MONTGOMERY COUNTY HISTORIC PRESERVATION COMMISSION
STAFF REPORT

Address:	Century Blvd, Germantown between Father Hurley Blvd and Winged Foot Ln	Meeting Date:	12/17/2025
Resource:	Burial Sites Inventory Waters (Zachariah) Family Burying Ground (HP-219)	Report Date:	12/10/2025
Applicant:	Dream Finders Homes, LLC (Symmetry/Poplar Grove development)	Public Notice:	12/03/2025
Review:	Comment prior to Planning Board	Staff:	Brian Crane
Proposal:	Parcel Subdivision and Water Family Burying Ground

POPLAR GROVE

PRESENTATION TO HISTORIC PRESERVATION COMMISSION

Figure 4: Plan view of proposed parcel boundaries around Waters Burying Ground (in red circle).

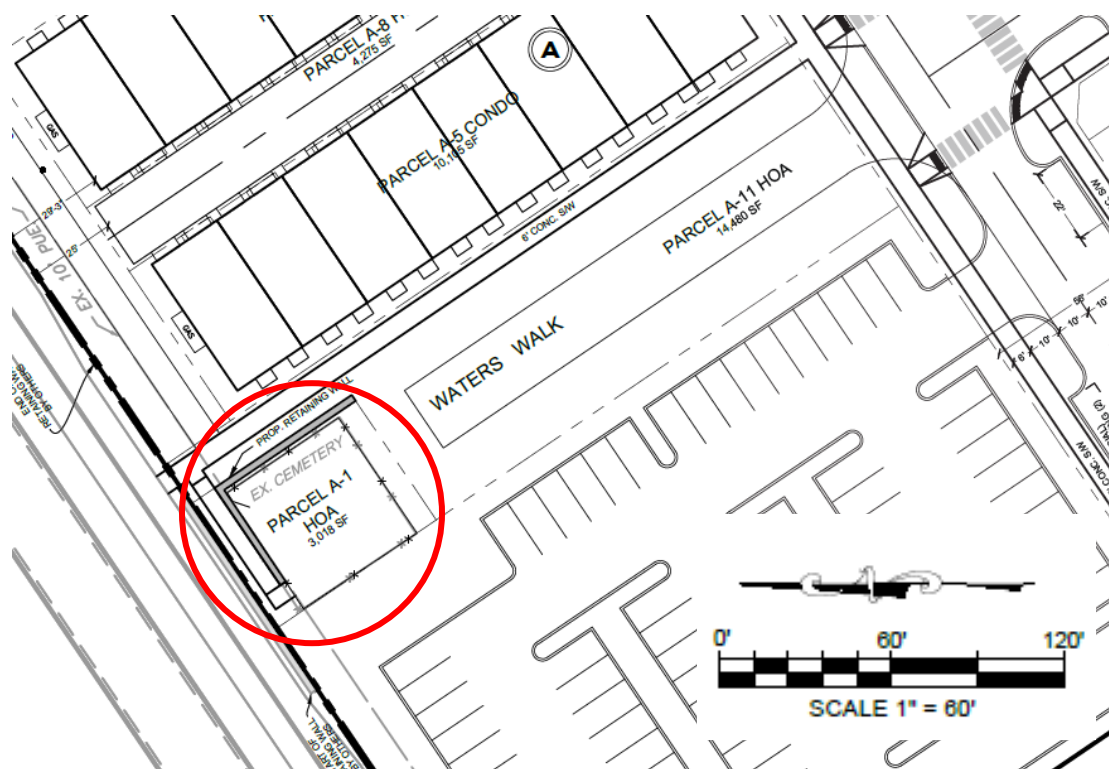
In September, the applicant submitted a draft preliminary plan that included lot lines flush with the present cemetery fence on the west side, 10 feet beyond the fence line on the north side, 2 feet on the east side, and approximately 5 feet beyond the fence on the south side (*Figure 4*). Staff recommended expanding the proposed parcel boundaries so that more of the buffer would be included in the cemetery parcel. The applicant responded by expanding the parcel boundary on the east and south sides to 7 feet and proposed pulling the fence back on the west side by two feet (*Figure 5*). The applicant did not adjust the parcel boundary on the west, proposed parking lot side.

Staff supports expanding the parcel boundary to 7 feet beyond the fence on the east and south sides of the cemetery, but remains concerned about the proposed lot lines on the west. Staff recommends expanding the parcel boundary to prevent future encroachment on the space surrounding the cemetery. If this is not possible on the west side, staff recommends an easement to guard against future encroachment. Staff does not support reducing the fenced area of the cemetery.

In addition, Staff recommends that the HPC support the concept provided that the buffer on the west side of the cemetery be protected in the future either through expanding the parcel boundaries or establishment of an easement. Staff does not support reducing the fenced area of the cemetery. Staff recommends that the stones be reset by a qualified conservator, and text for interpretive signage be developed in consultation with Historic Preservation staff.

Figure 6: Proposed plantings, retaining walls, pavements in Waters Park.

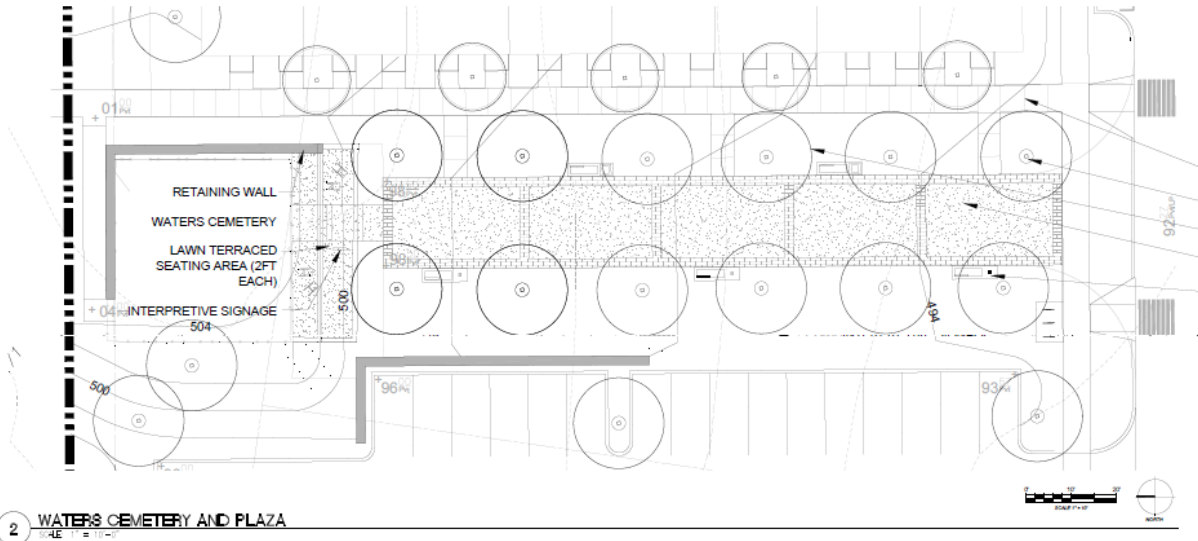
The proposed park includes a paved walkway, shade trees, plantings, interpretive signage, benches, and a fence to screen adjacent parking (*Figures 6-8*). Staff supports this concept. It will facilitate preservation, access and appreciation of the Waters Family Cemetery. It is unclear whether the applicant intends to reset the toppled grave markers within the cemetery: some concept renderings show the markers upright, while others show the markers in their present condition. Staff recommends that the developer have the markers reset by a qualified stone conservator. Staff also recommends that the applicant develop text for proposed interpretive signage in consultation with Historic Preservation staff.
